135-3
Elev B
3pc

Zancor Homes
Wasaga Townhomes

PARTIAL GROUND FLOOR ELEV 'B'

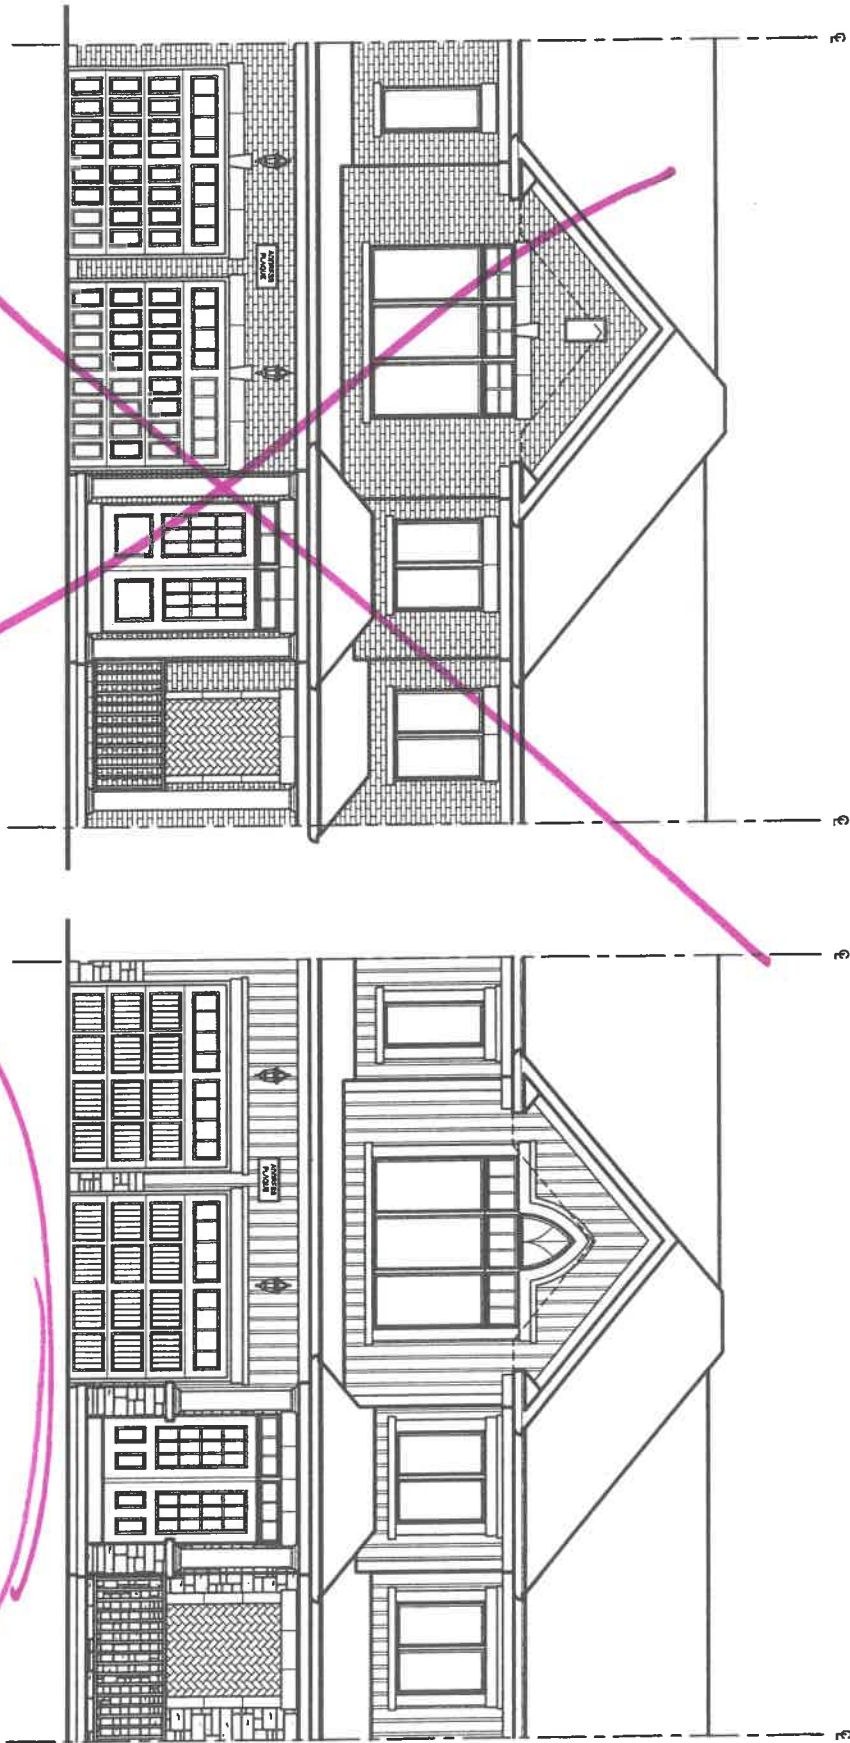
— Shift!
over ↑

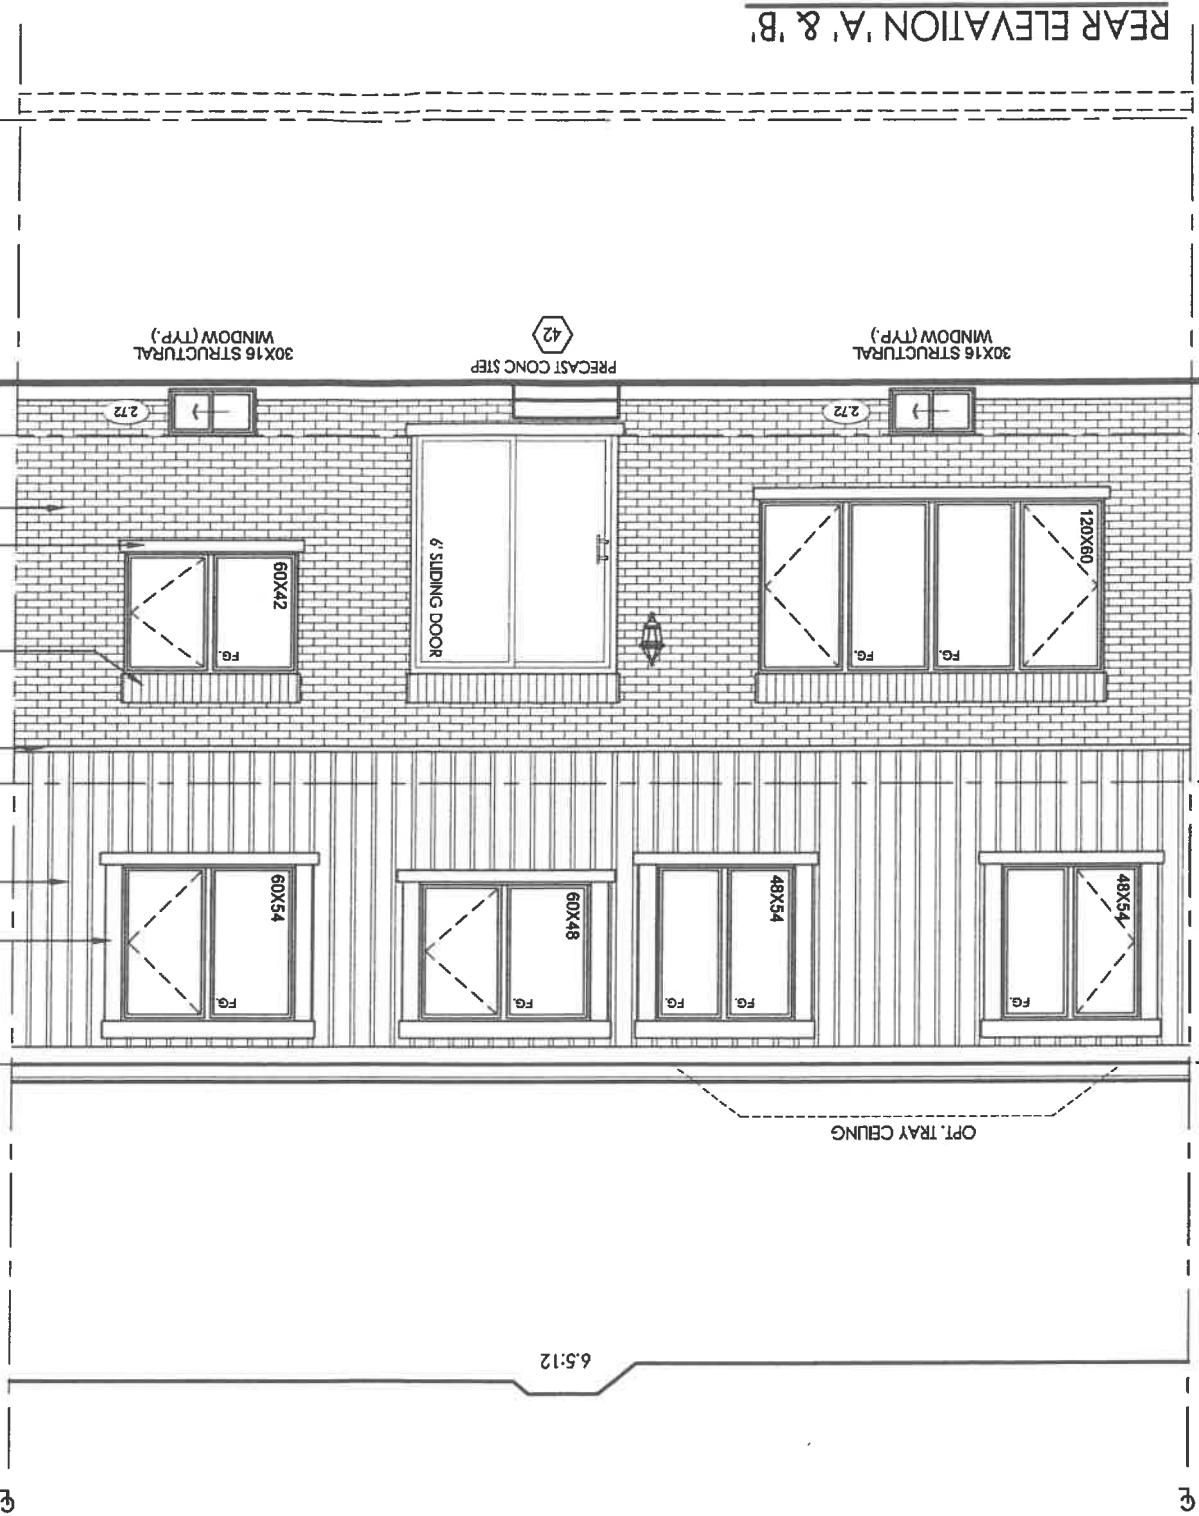
shift over 1'

SECOND FLOOR ELEV. X

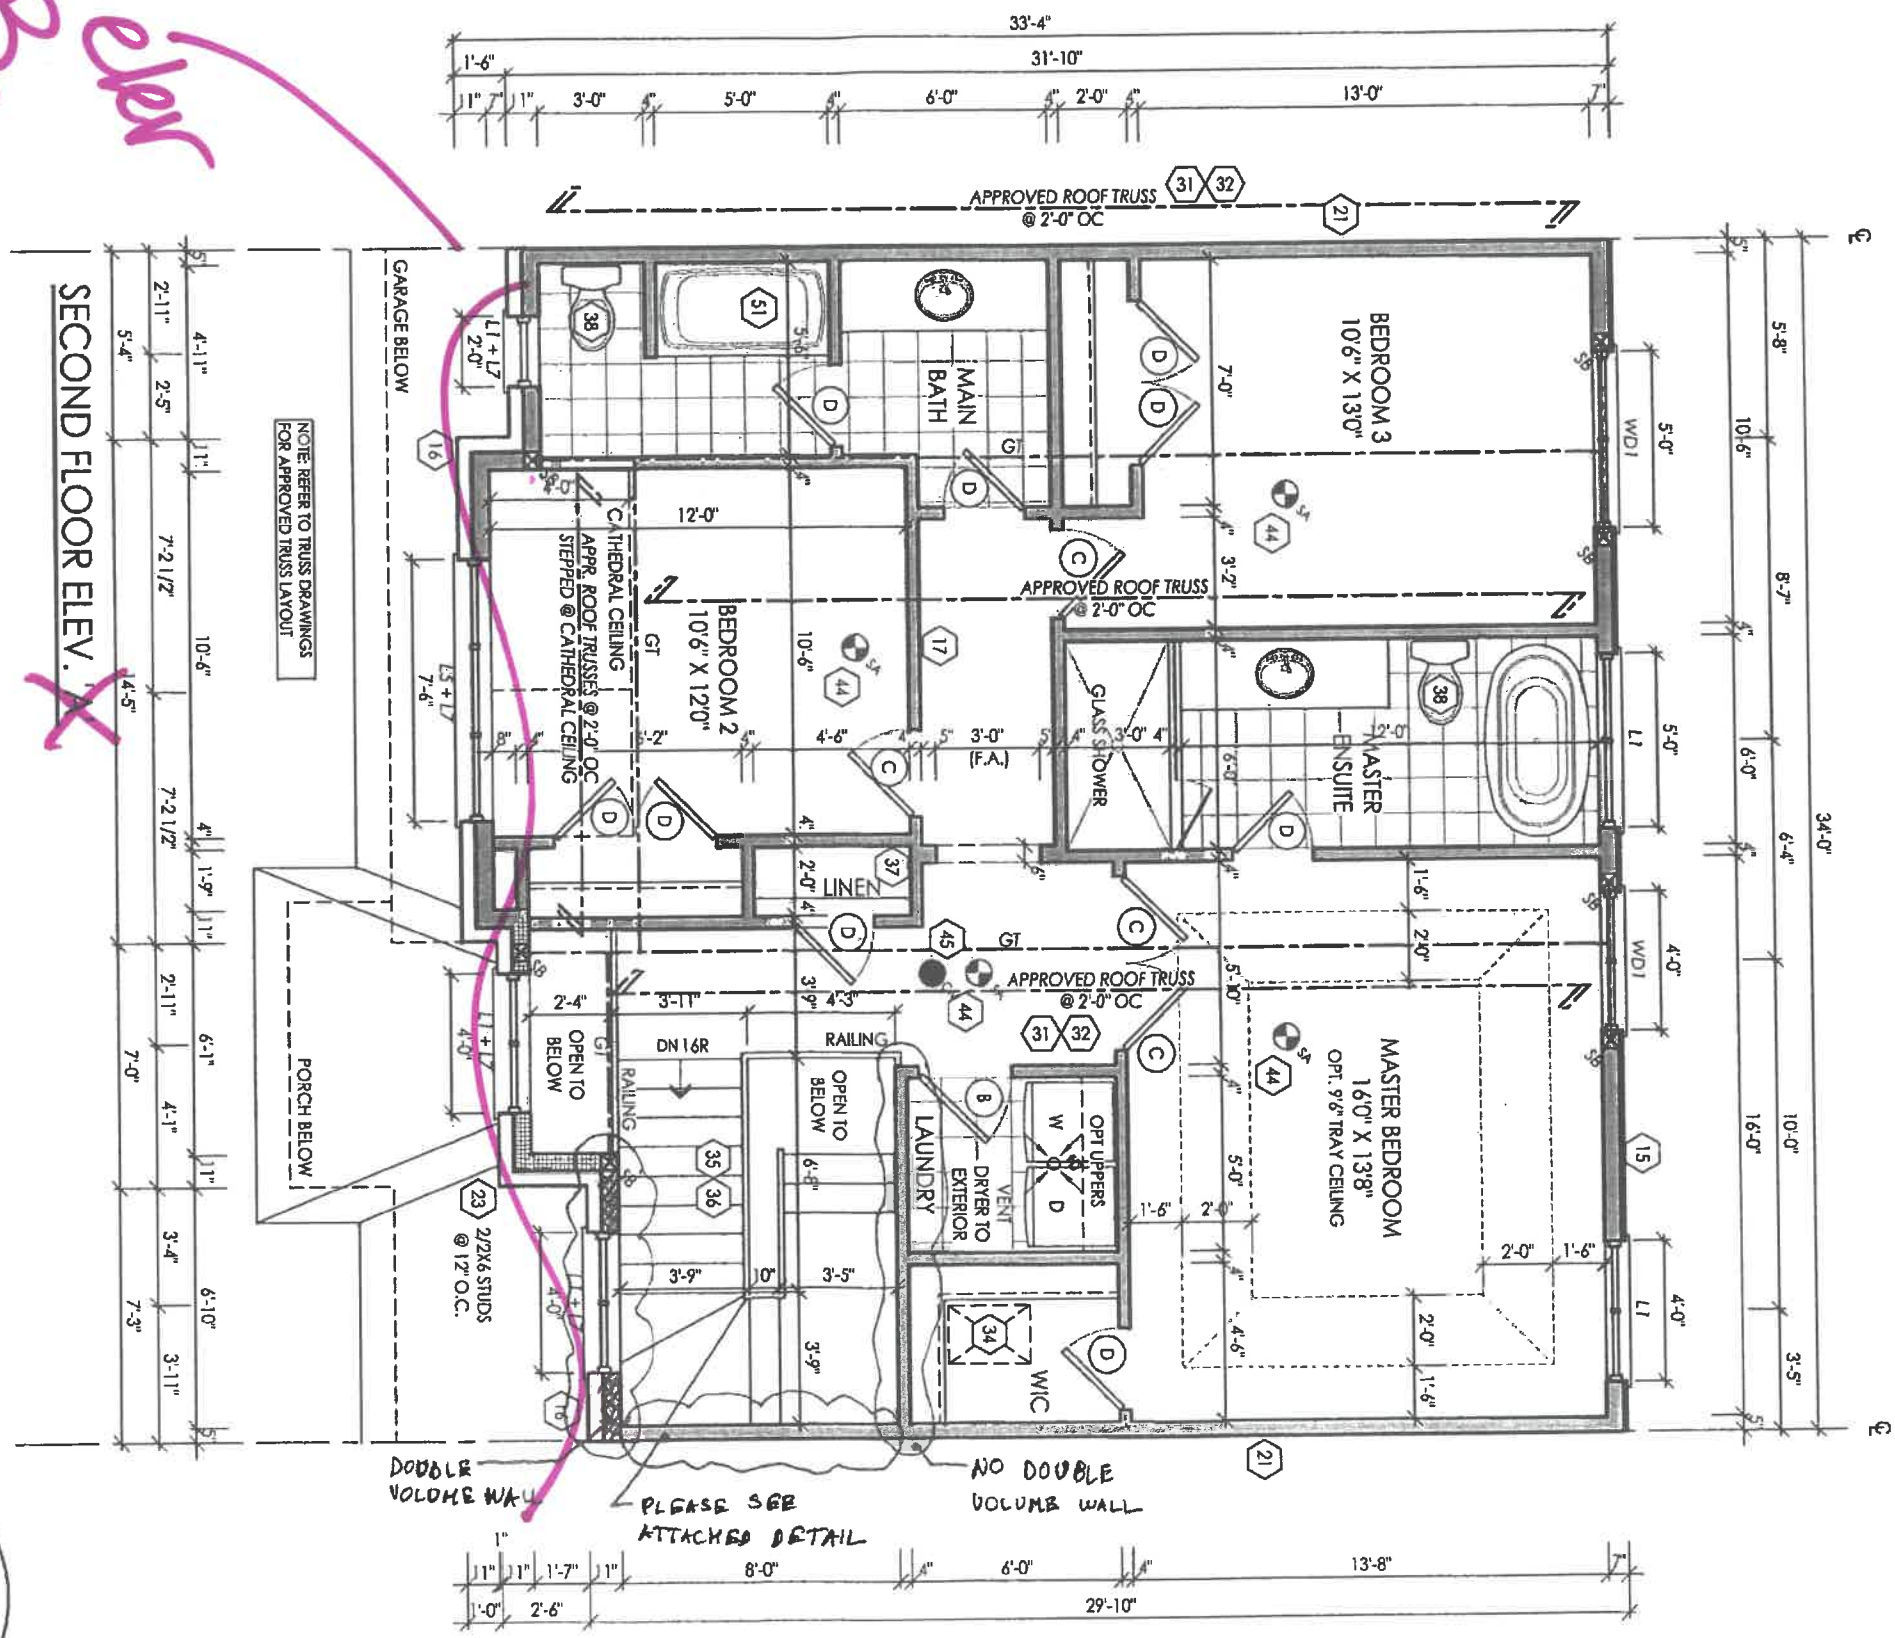
See elev B.
